ORDINANCE NO. 2009-011

AN ORDINANCE GRANTING FINAL SITE AND LANDSCAPING PLAN
APPROVALS FOR THE PROPOSED BUILDING ADDITION TO ZF INDUSTRIES
LOCATED AT 777 HICKORY HILL DRIVE, IN THE VILLAGE OF VERNON
HILLS, LAKE COUNTY.

TECHNICAL REVIEW SET JANUARY 28, 2009 TECHNICAL REVIEW COMMENTS FEBRUARY 20, 2009

FROM: Chuck Kamminga, Plans Examiner
SUBJECT: Technical Review Comments #1

PAVEMENT DETAILS

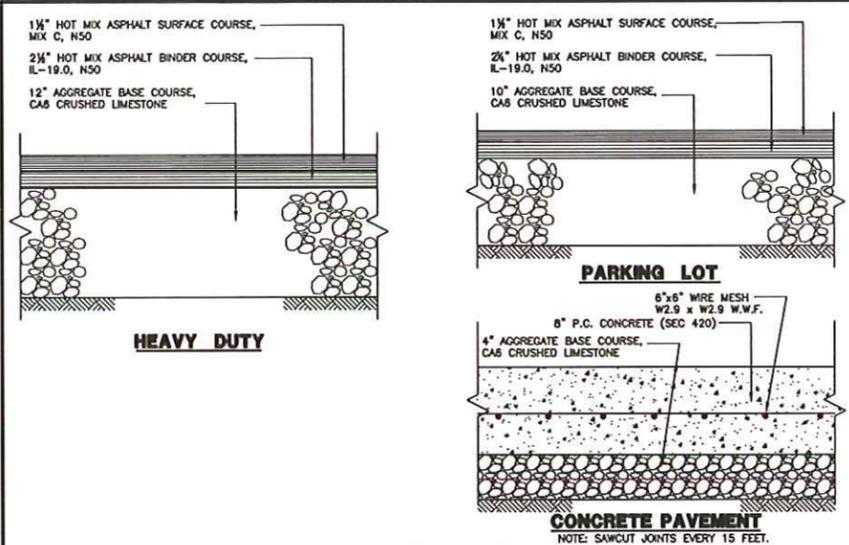
Staff has been advised that the project is to meet current ordinance based on the expiry of the original development agreements. The new pavement cross sections will need to be revised.

Revise the Heavy Duty Pavement Detail to meet minimum Village Standards as follows:

Revise the Parking Lot Pavement Detail to meet minimum Village Standards as follows:

Revise the Concrete Pavement Detail to meet minimum Village Standards as follows:

The drawings have been revised to indicate compliance with the current ordinance for the new pavement cross sections.

SCALE:	1"=50'	PROJECT:	ZF INDUSTRIES - 777 HICKORY HILL DRIVE
DRAWING NO.:	54130	SHEET:	5 OF 8
		UTILITY PLAN

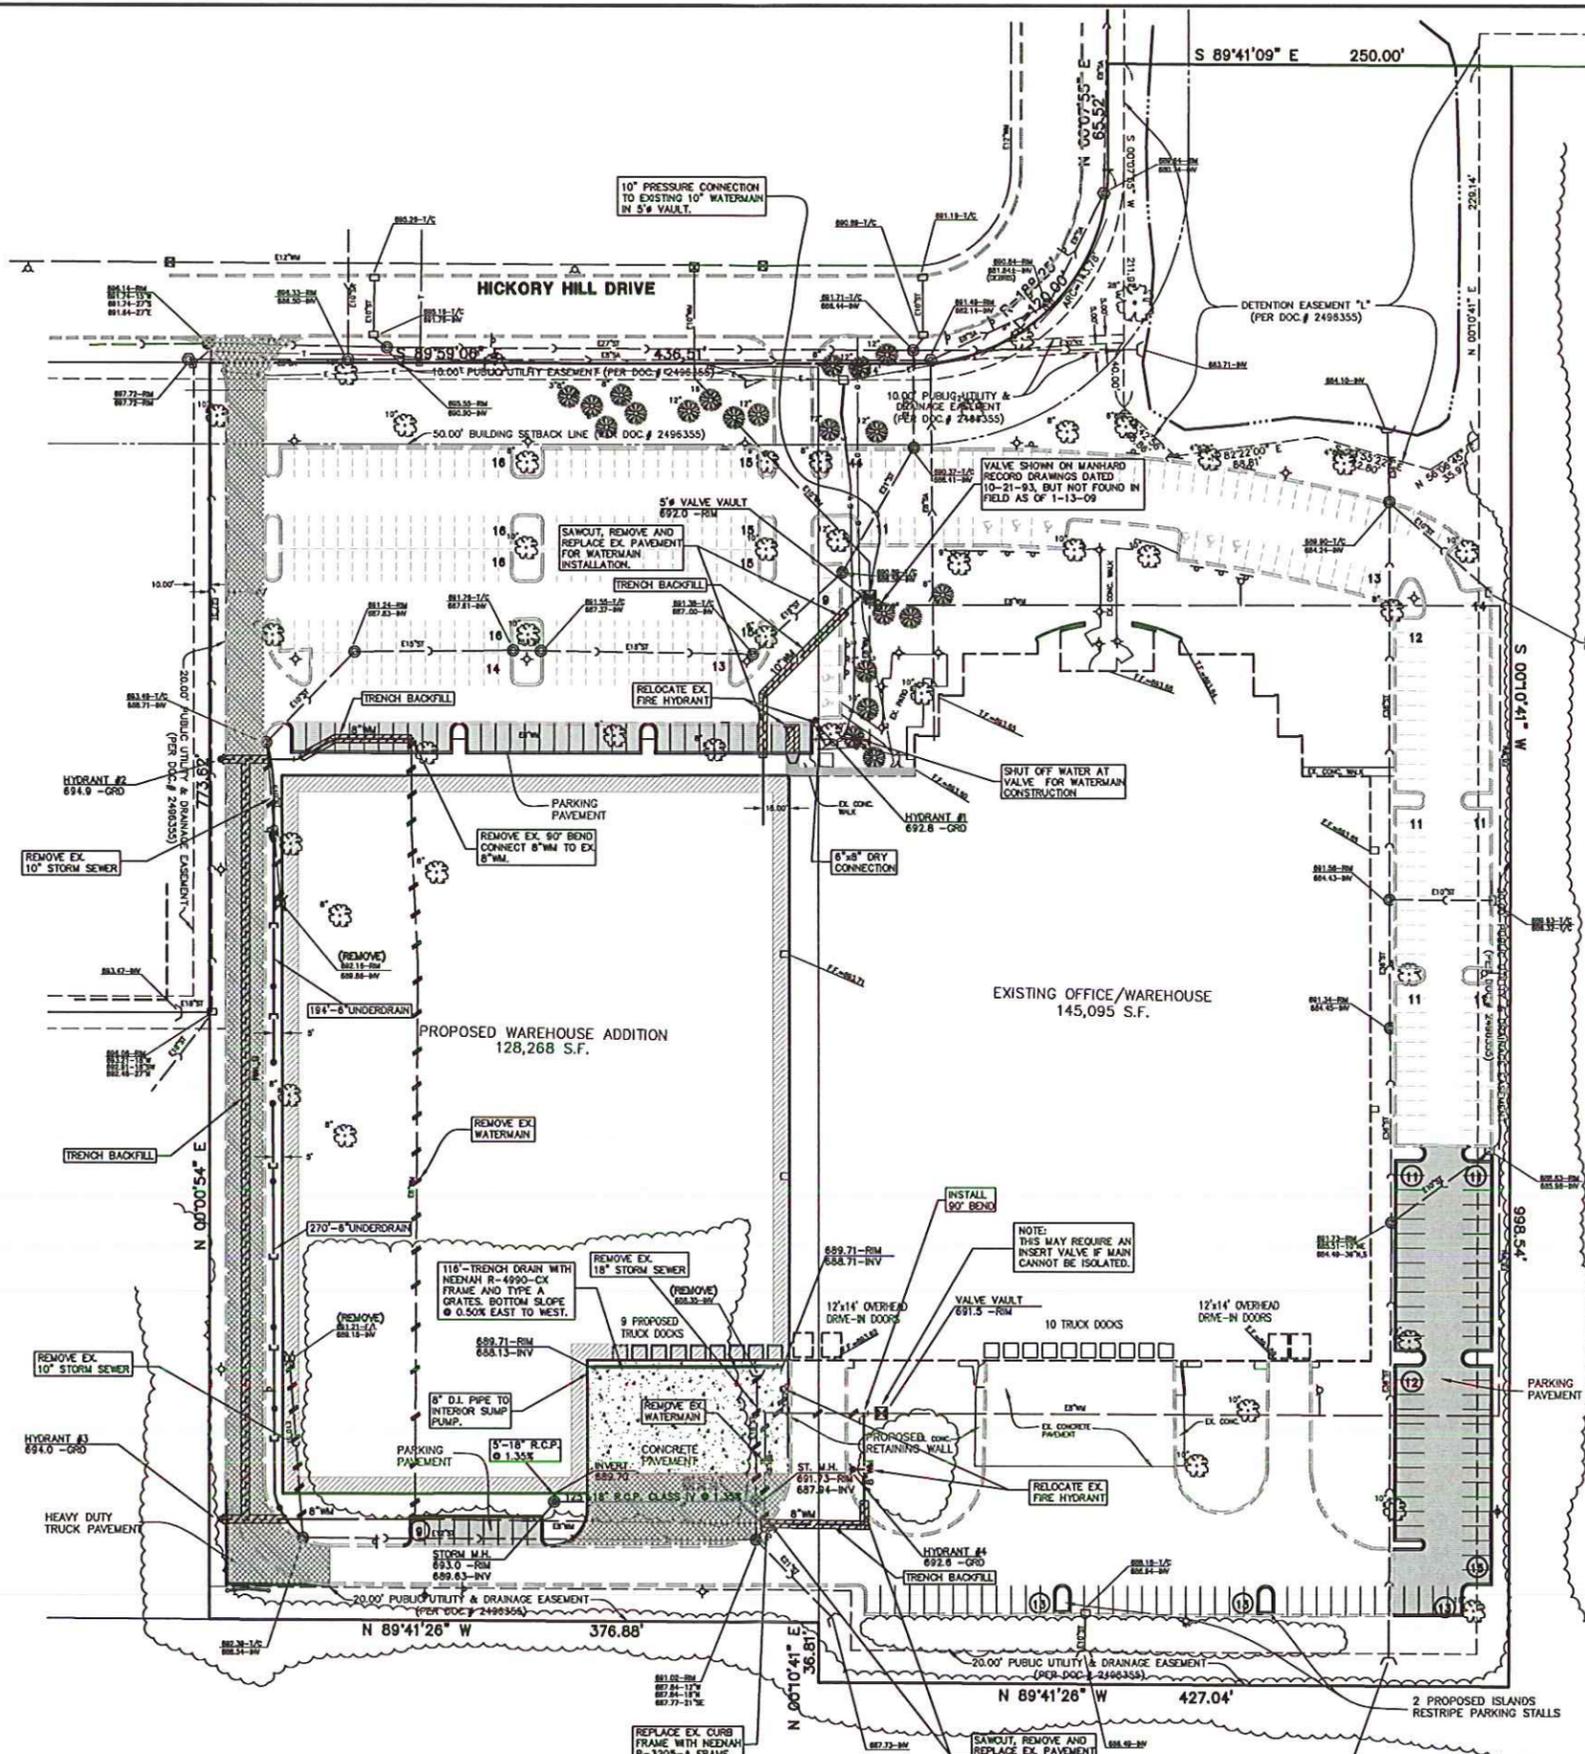
retaining wall possibly creating limited access. Provide better access to the hydrant than what is proposed.

Fire hydrant #4 is being relocated from near the new retaining wall to approximately 70'-0" to the southeast of its current location. This is indicated on Sheet 5 of 8 of the civil engineering drawings.

DRAWN BY: RAM
CHECKED BY: RAM
DATE: 01-12-09
SHEET NO: 2
PP-1 OF 2

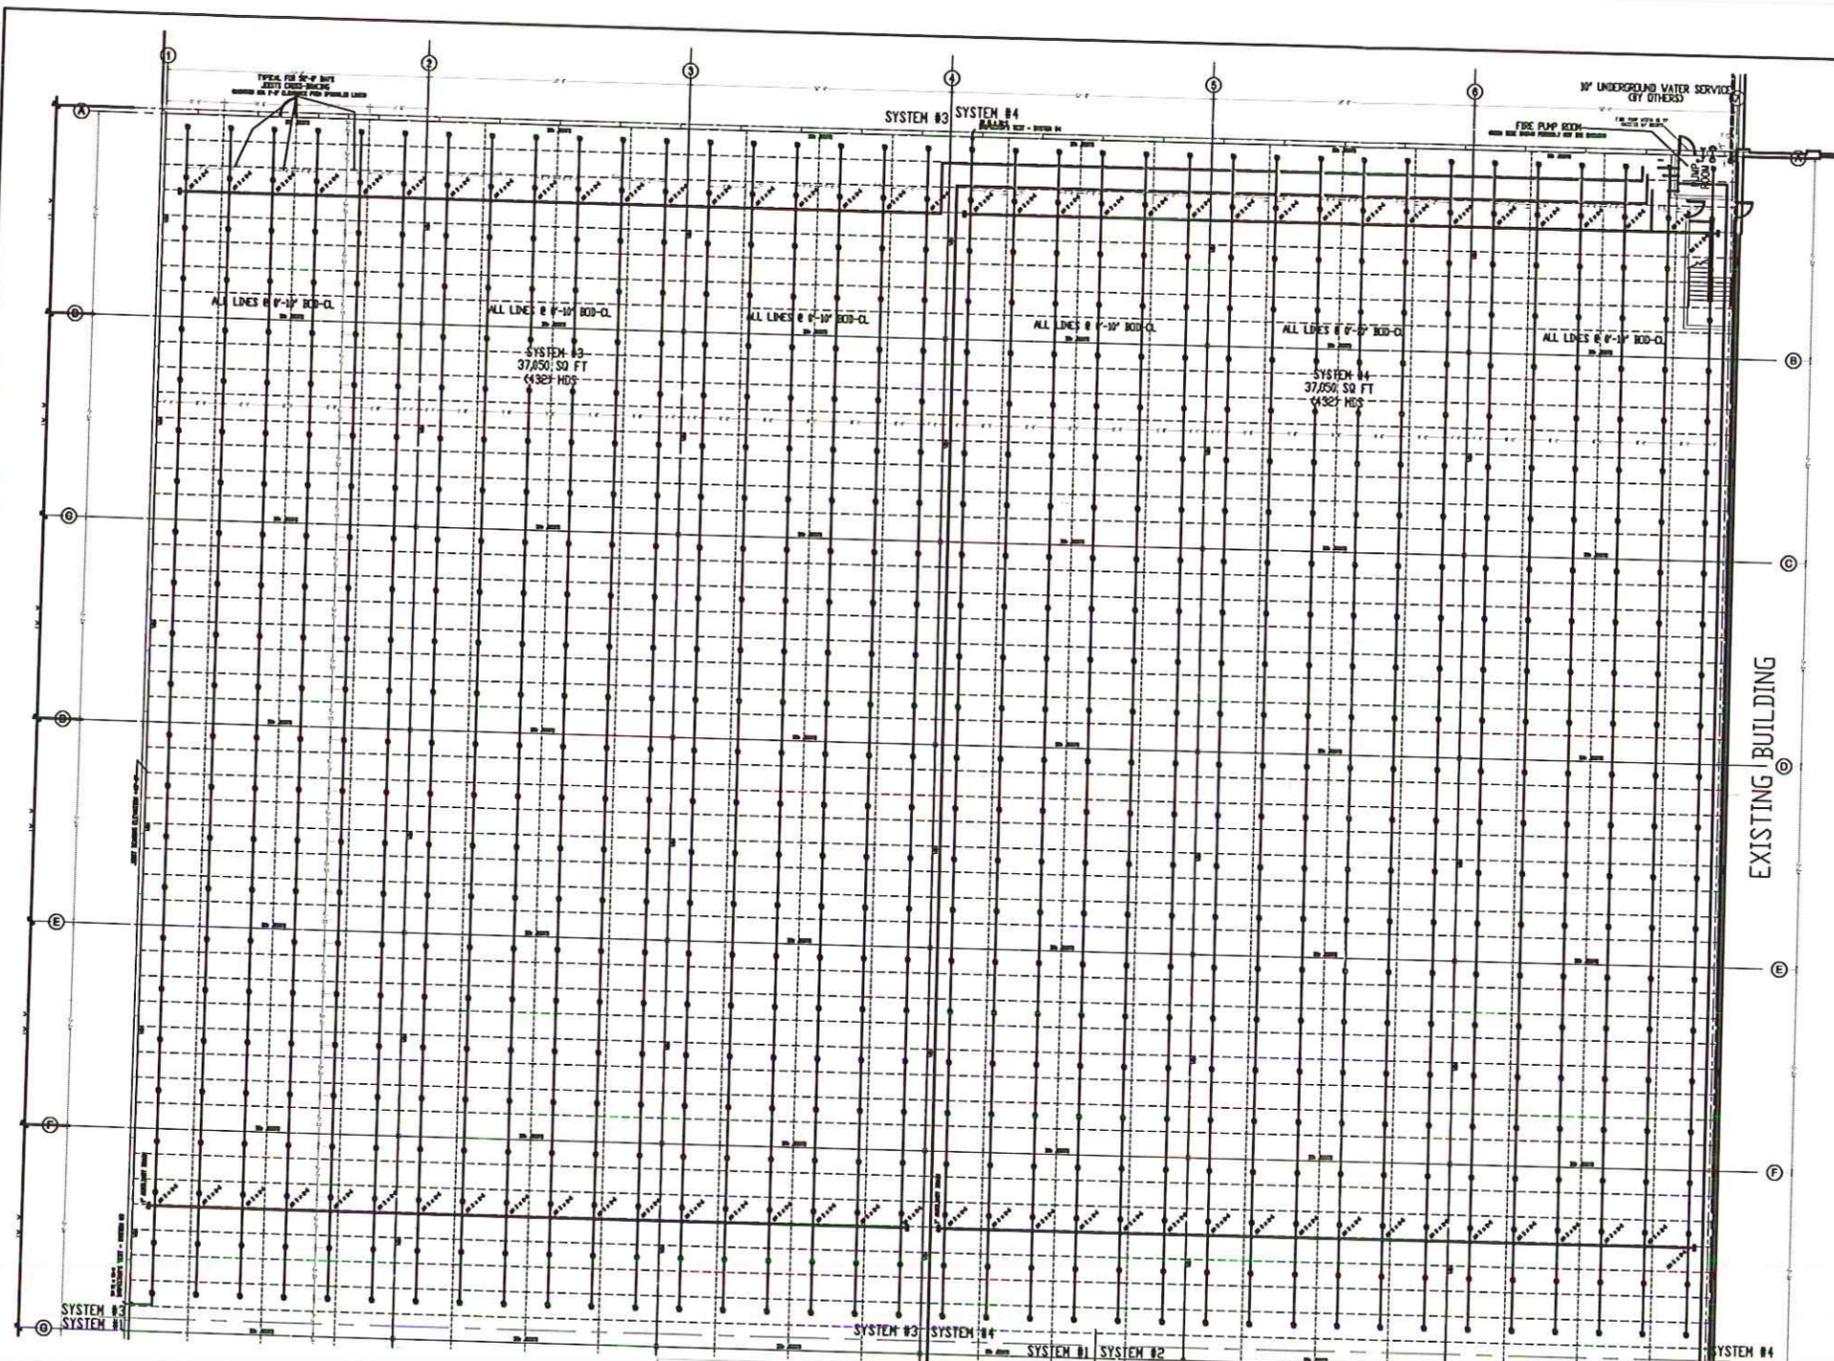
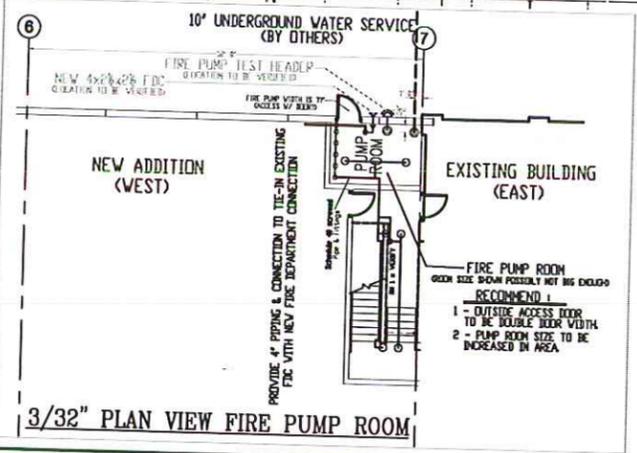
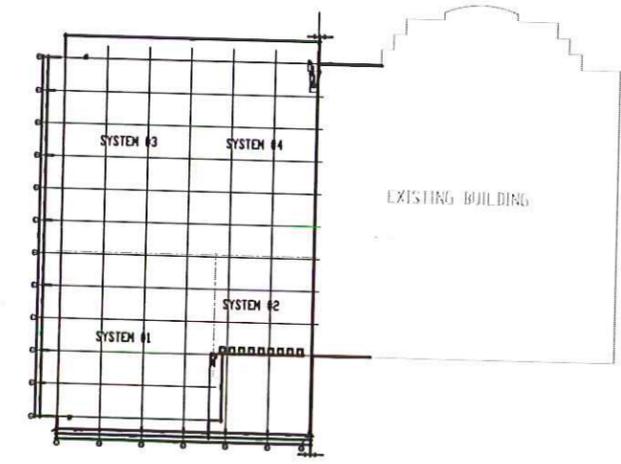
1. We require a sprinkler head count for the proposed facility. The plan set received does not have that information.

We have included sprinkler drawings, FP-1 and FP-2, in our resubmittal. The total number of sprinkler heads is indicated on Sheet FP-1.
